RE: THOMAS STREET CAR PARK, CHATSWOOD - MP 09_0066 MOD 7

I refer to Willoughby City Council's letter of the 21 May 2013 that responds to our amendments made to the basement car park level. The main issues in Council's letter relate to the separation of the public car park, lift use and Relative Levels. Each of the issues is addressed below.

A-0113 F
CONSTRUCTION CERTIFICATE

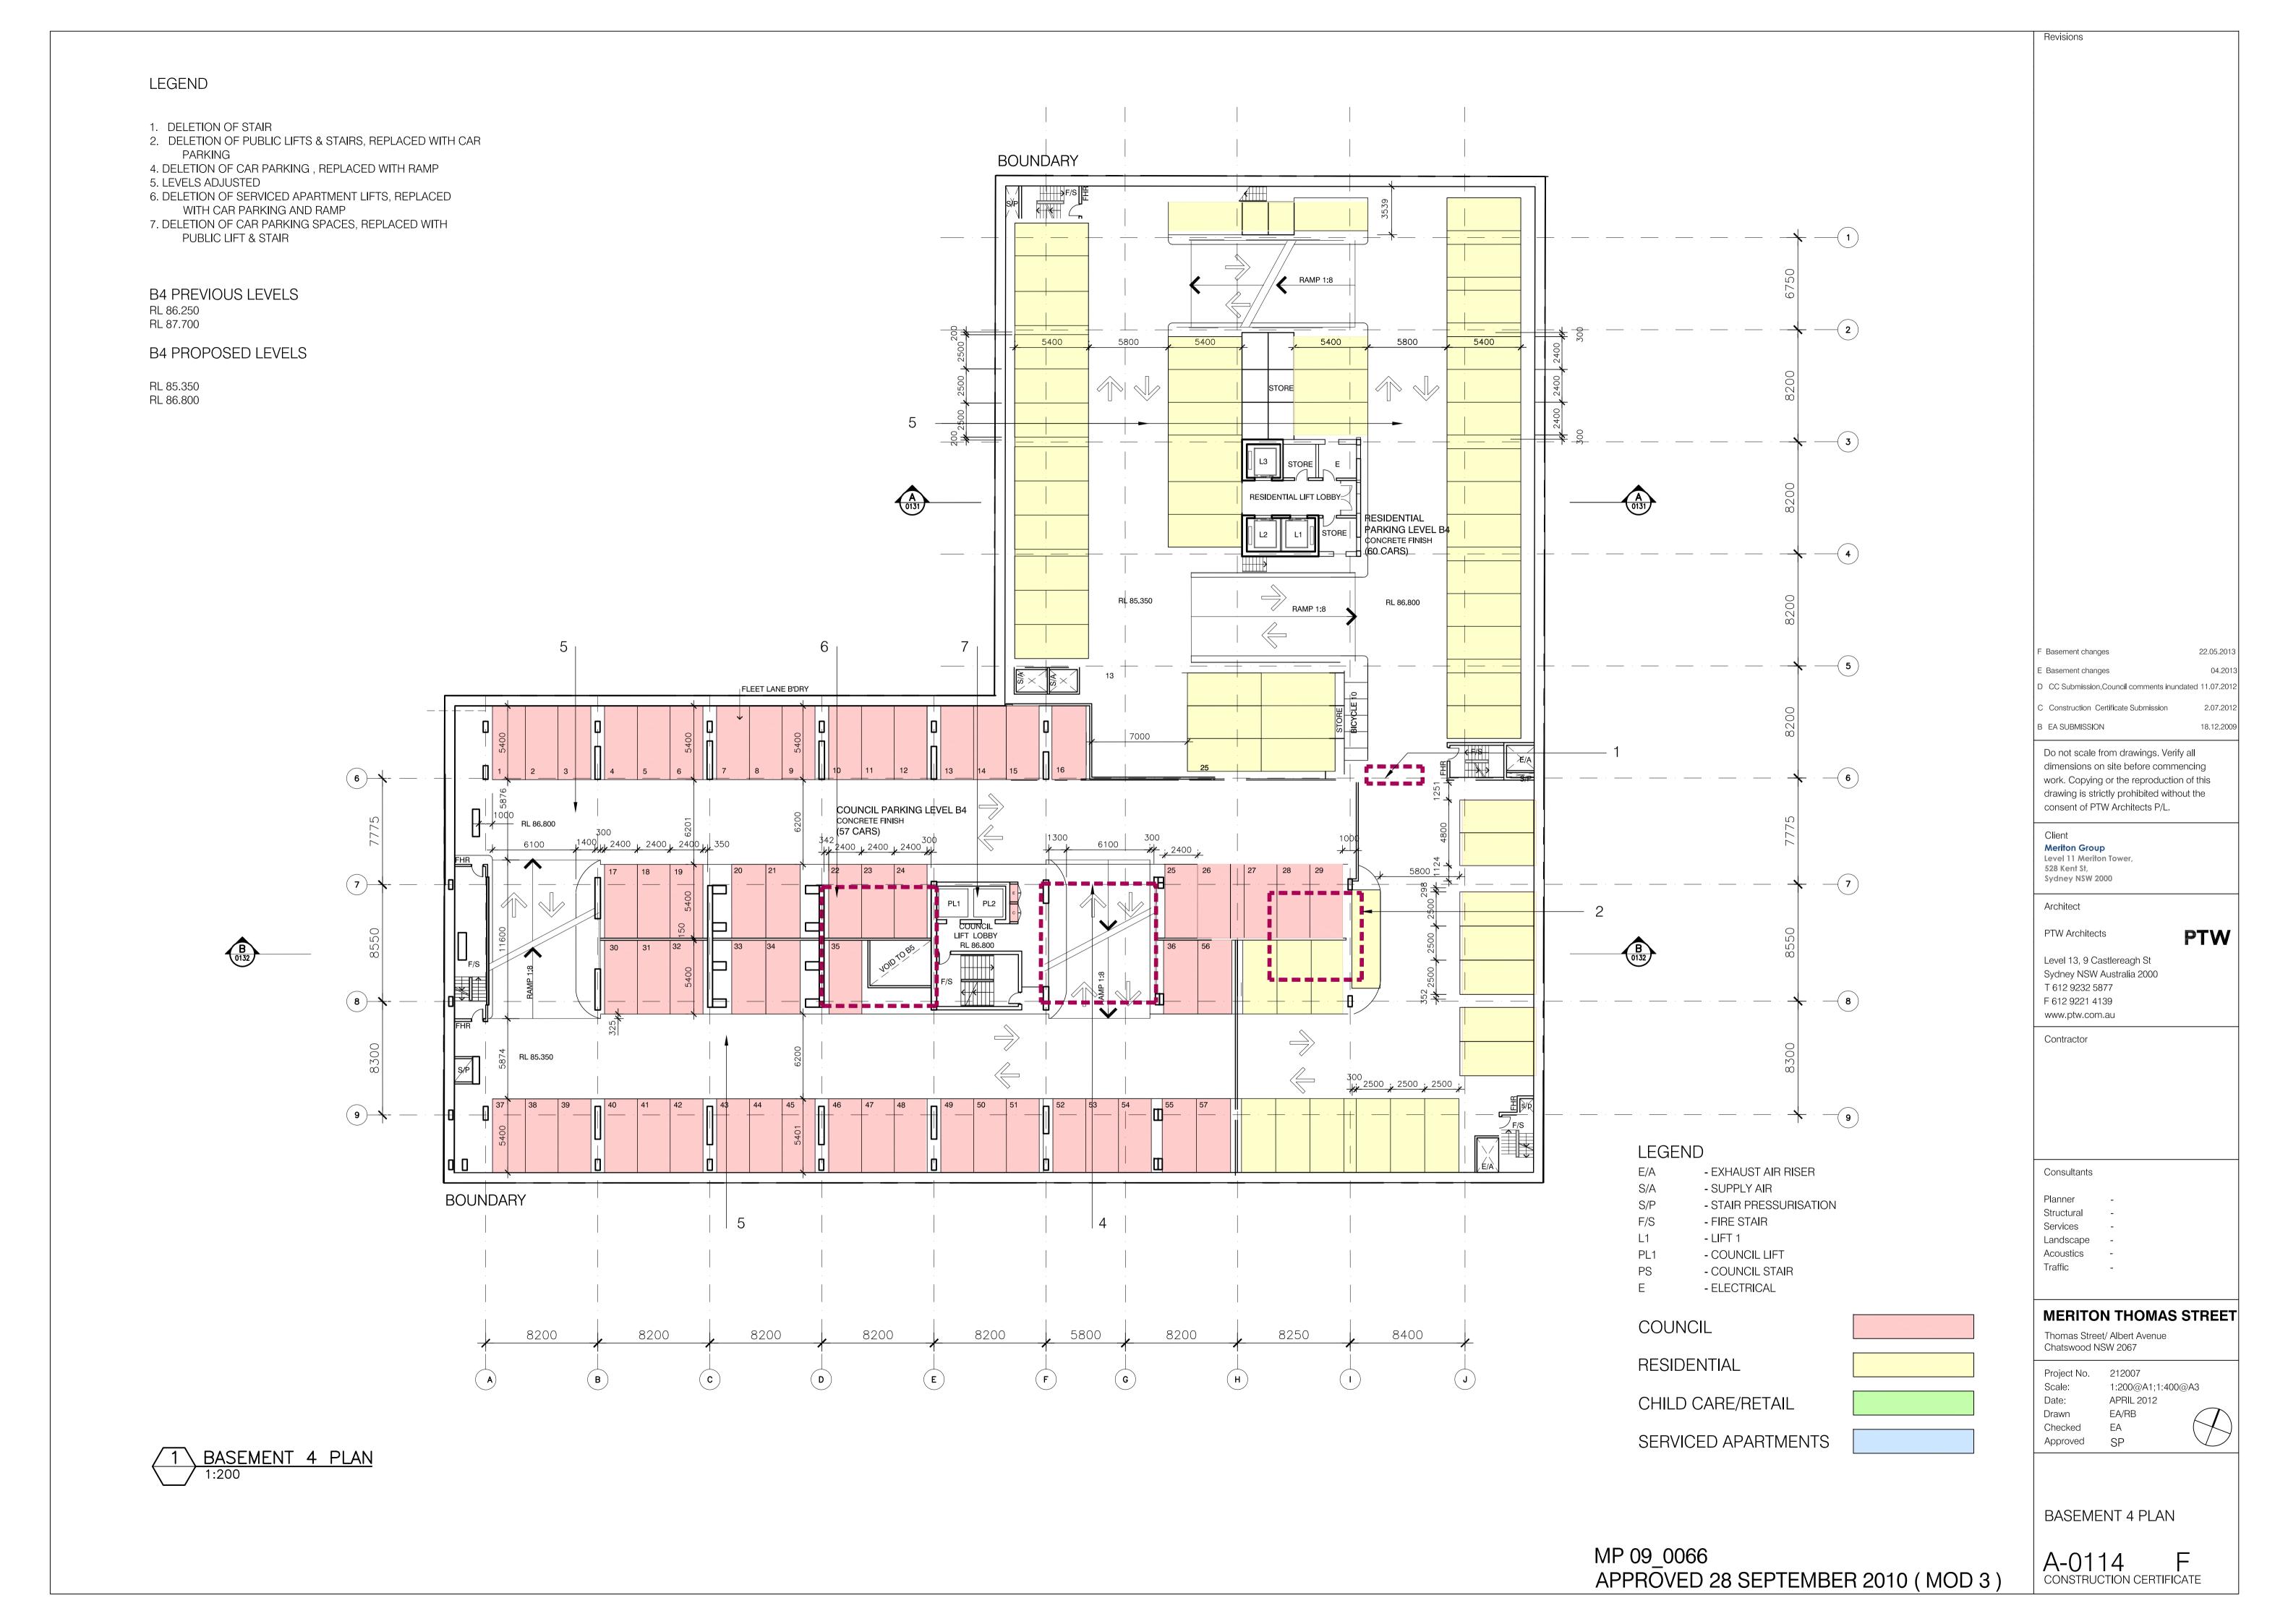
<u>Basement Levels 3, 4 & 5</u> – Walls have been made clearer on the plans that isolate the public car park from any other use.
